ST. TAMMANY PARISH

Addendum No.: 2

Quote #: 26-20-1

Project Name: Lafitte St Drainage

Attachment G - Revised– Addendum No. 2

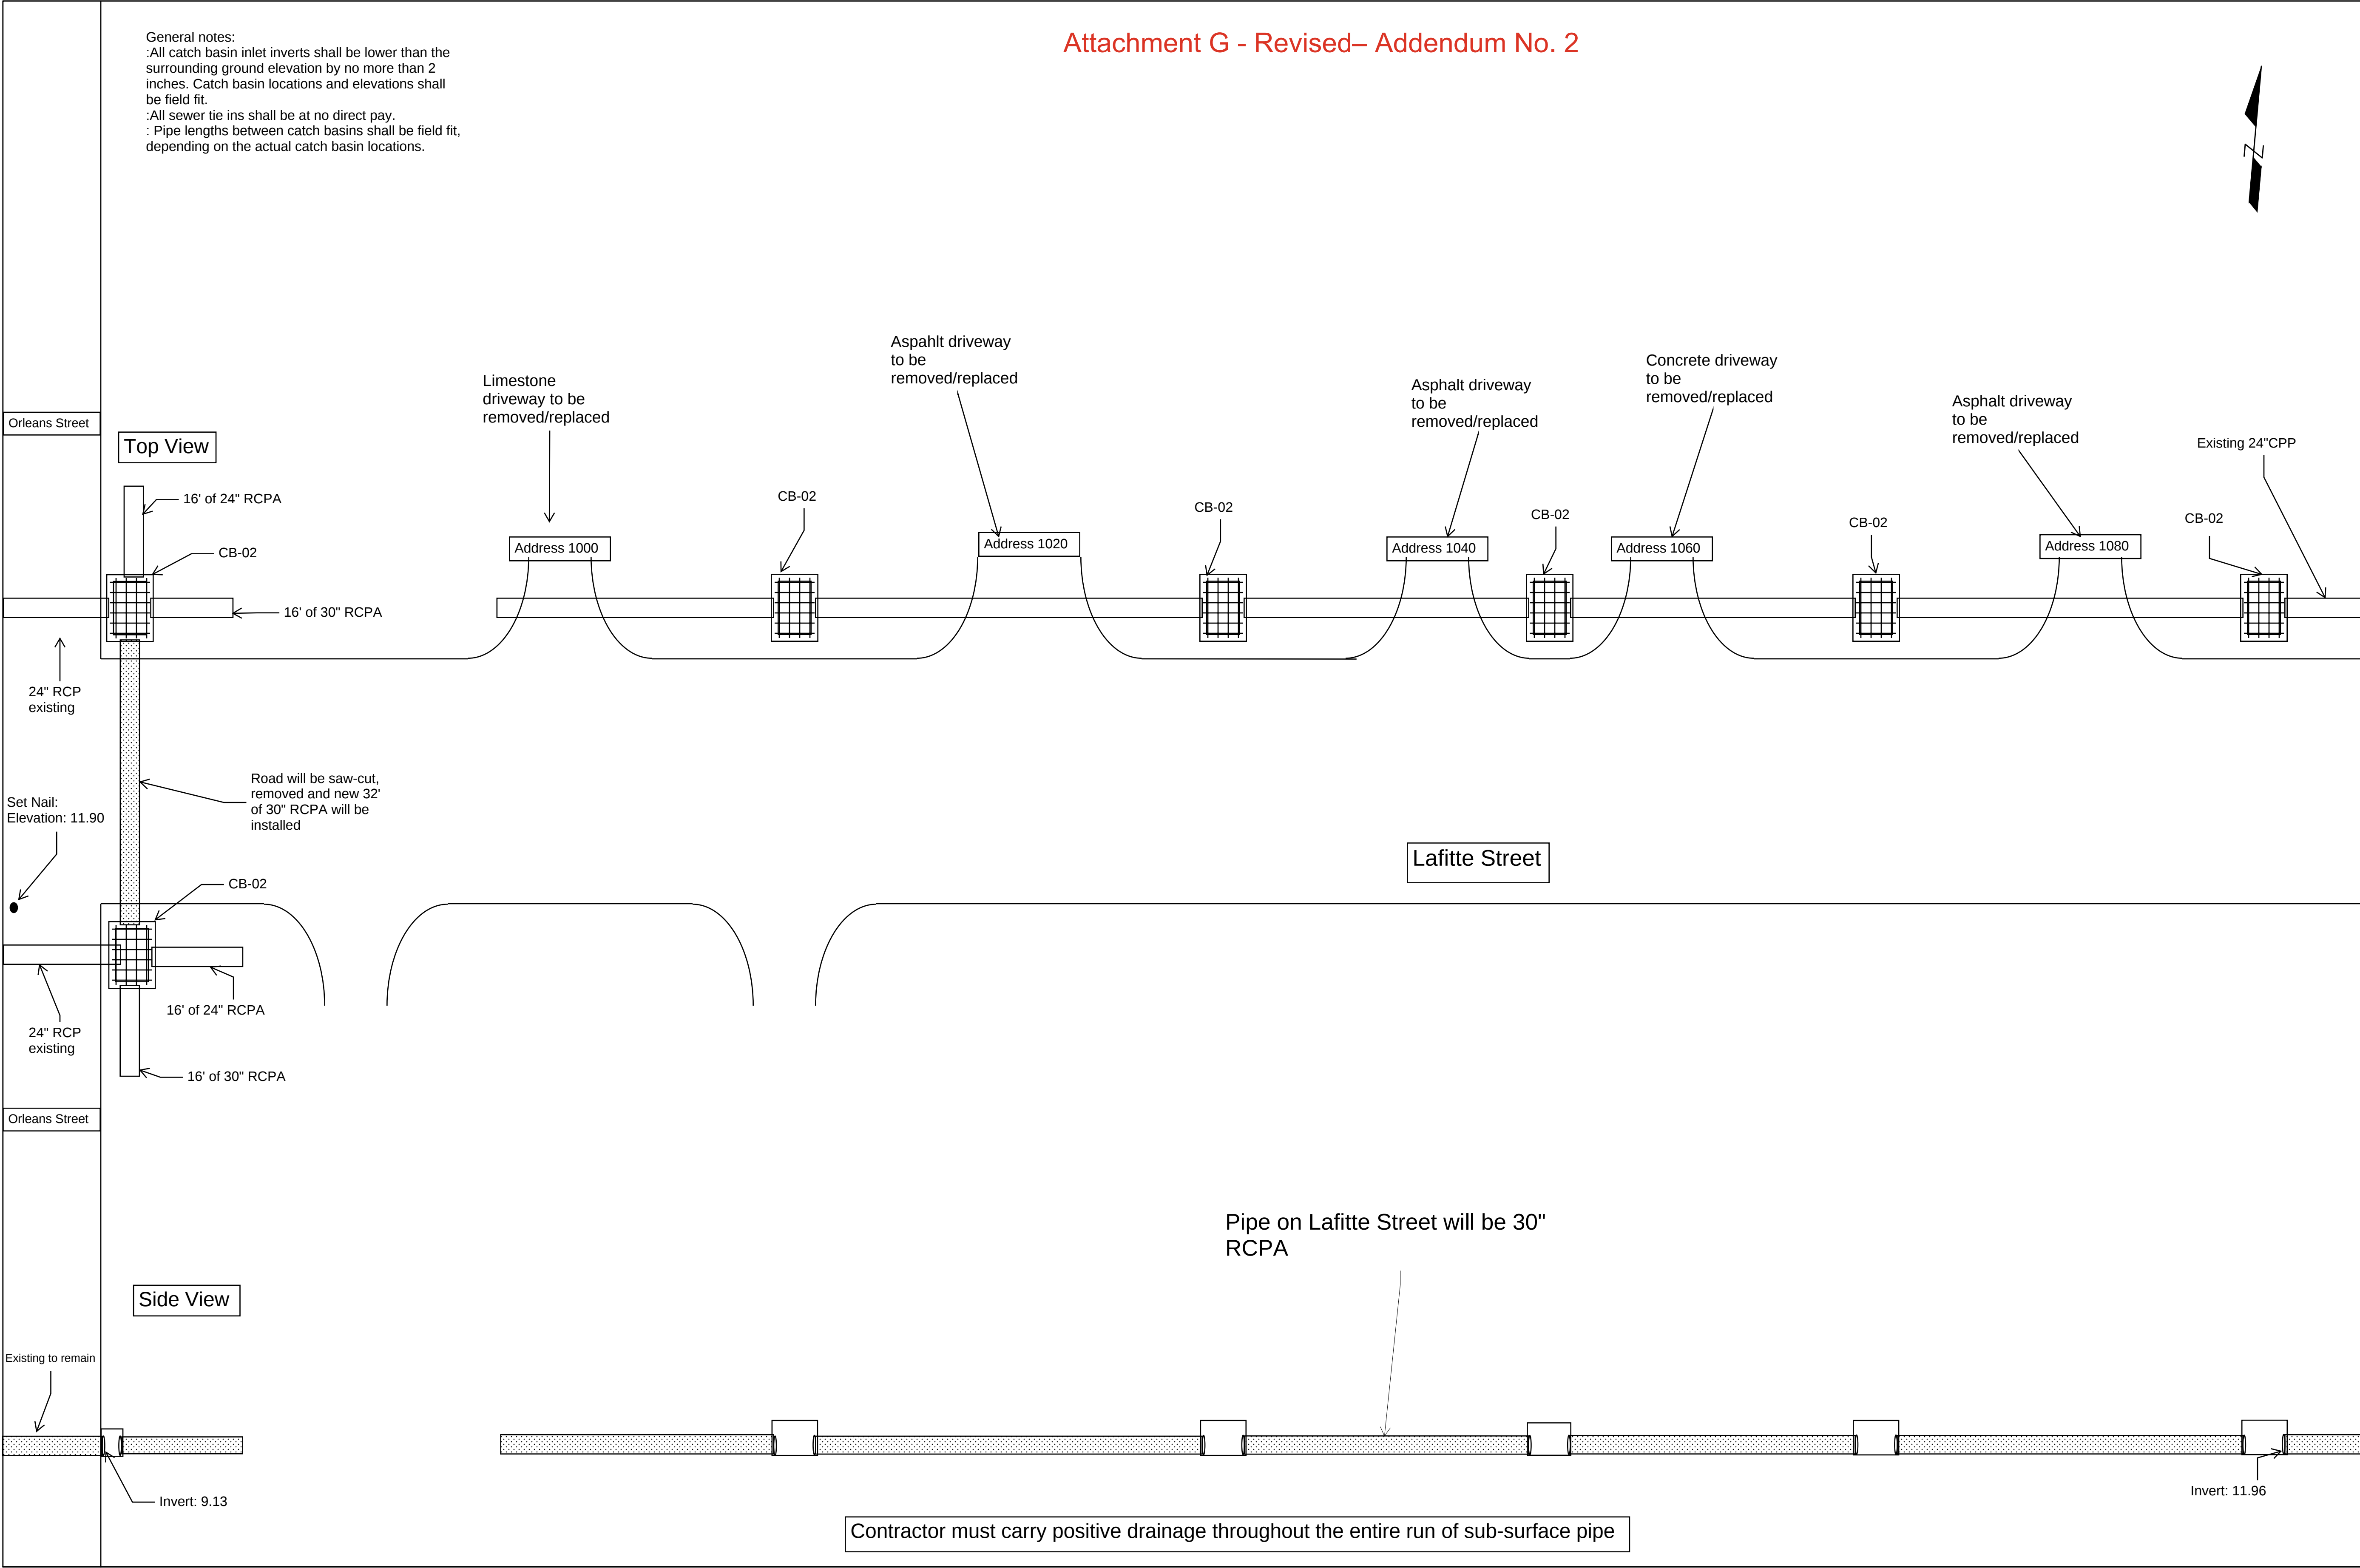
1. Please note that the Quote opening has been pushed to **Tuesday, July 28, 2026**. Time and location remain the same. The inquiry deadline is **Tuesday, July 21, 2026**. The addendum deadline is **Thursday, July 23, 2026**.
2. Please remove Attachment G – Layout - Revised and replace it with Attachment G- Layout – Revised – Addendum No. 2 (attached).

Question 1. After reviewing the plans, it appears that the quantities for the 24-inch RCP and the 30-inch RCP may have been switched. Based on our review, it seems the quantity shown for the 24-inch RCP should apply to the 30-inch RCP, and vice versa. Could you please confirm whether the quantities have been mixed up, or if we are interpreting the plans incorrectly?

Answer 1. Please note that the unit price form and the specifications were correct in quantities. However, Attachment G – Revised had an incorrect note. Please refer to General Information #2.
